4.3 Jones Bay Road F&B Tenancy

4.4 Revised Ritz Carlton to Star Resort links

4.5 Car Stacker

Revised AF1004 Level 04 + Level 04 Mezz Floor Plan - without VIP link

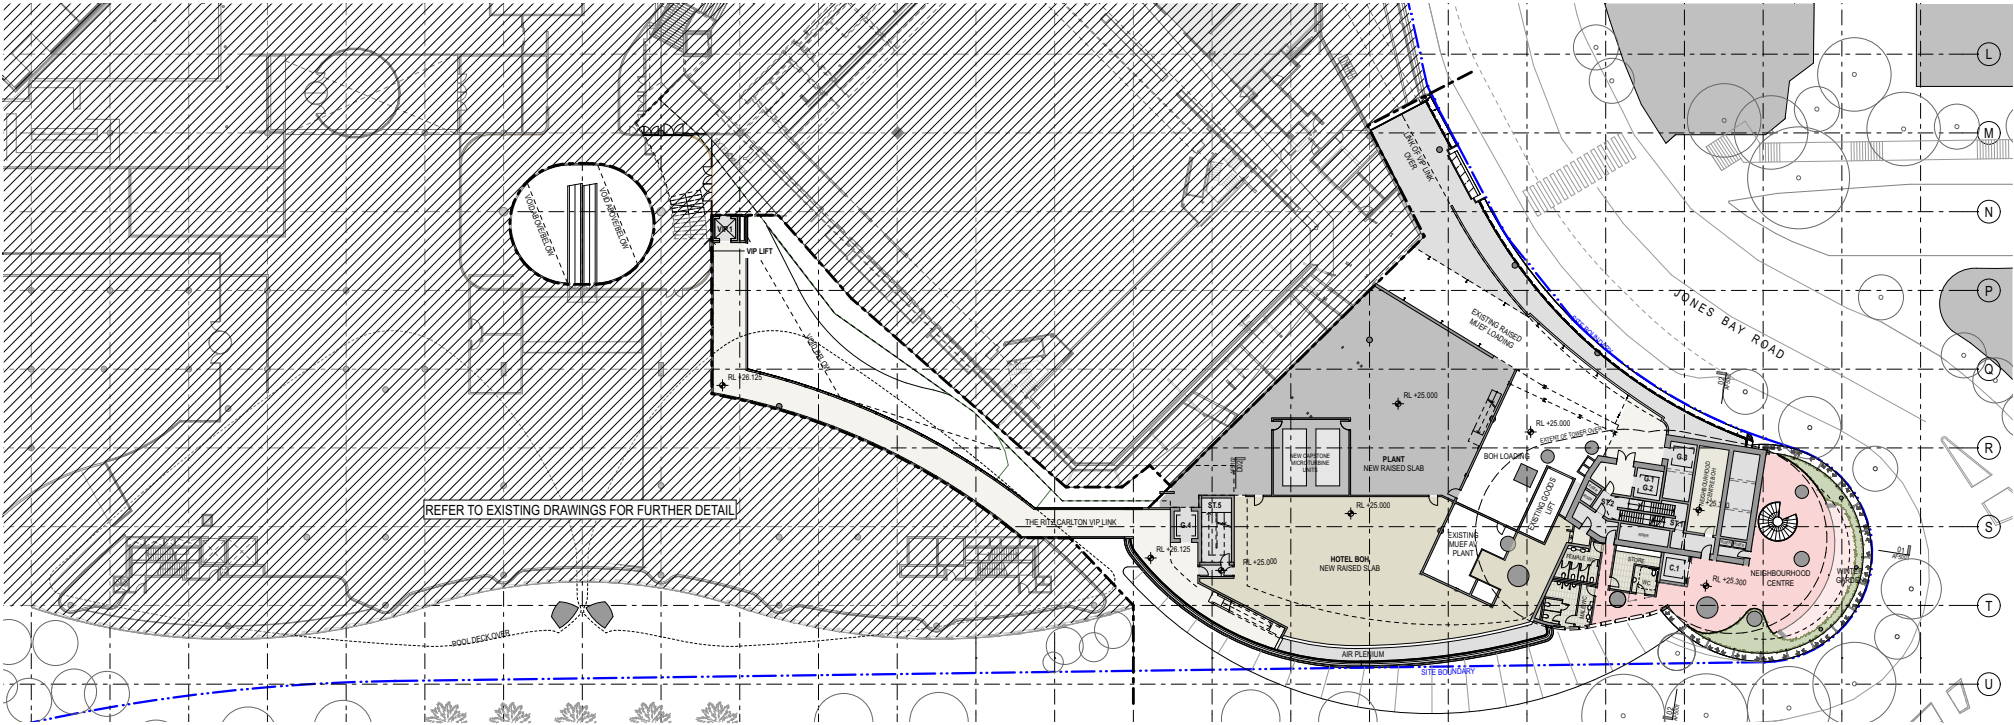
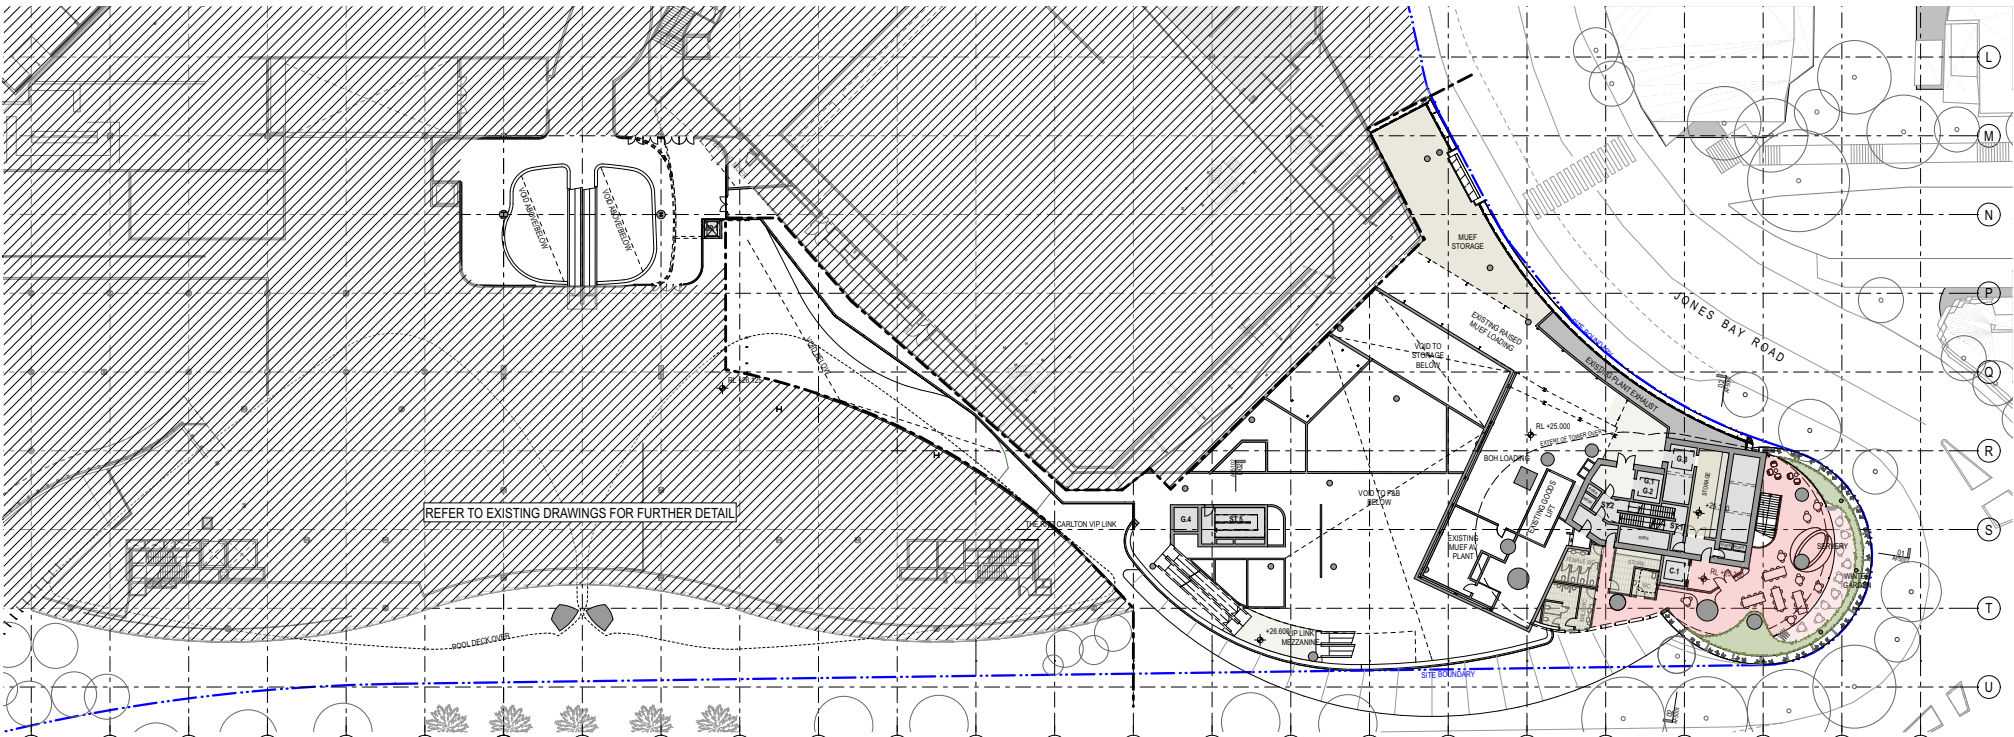
High level L04 - Sovereign VIP link (Removed)

The second redundant link was designated at L04 and transitioned through the North F&B tenancy proposed in MOD 14 (shown right top). This resulted in reductions to head height and clearances to the tenancy and complications with a proposed plant room adjacent to the core, stair and associated service rises. This link has been removed to simplify access paths and tenancy conditions as proposed in MOD 14.

Revised AF201 B5 Floor Plan - with updated efficient car stacker layout

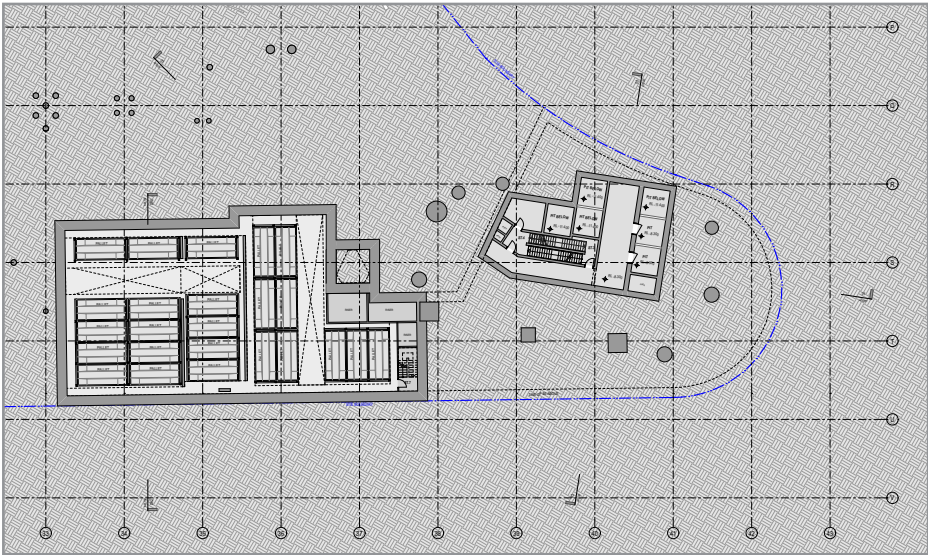
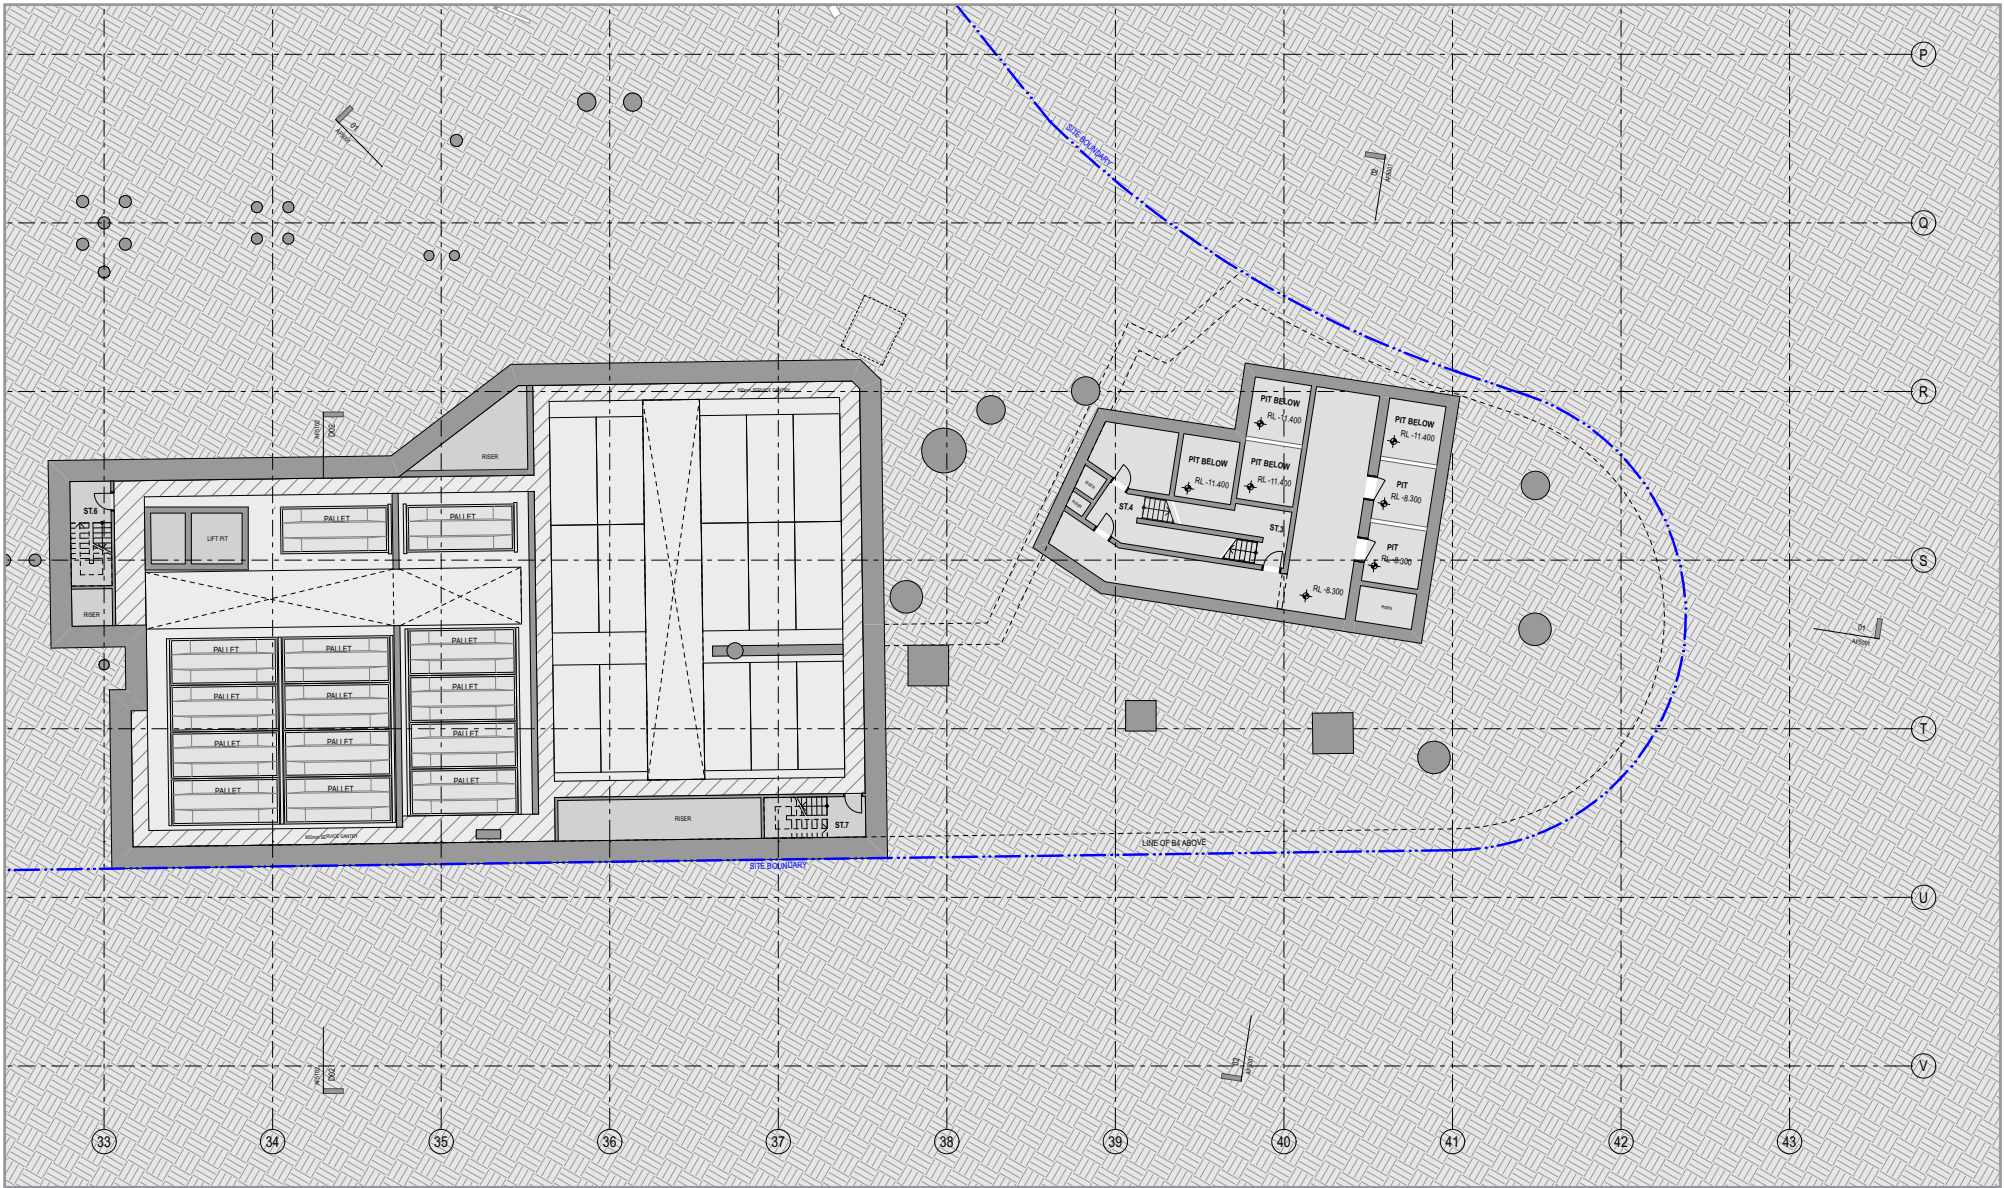
Continued development of the car stacker and basement envelope since formal lodgement has resulted in improved efficiencies with a reduction of basement excavation of two levels.

The revised plan (right) highlights the updated basement envelope with removal of existing legacy structure and increased capacity of system 1. This update has also captured an additional egress stair allowing 2 points of egress for access and fire fighting purposes.

The improved spatial efficiency will result in a quicker construction time and removal from site of a reduced amount of excavated material. As such, this amendment is seen as positive in terms of construction impacts
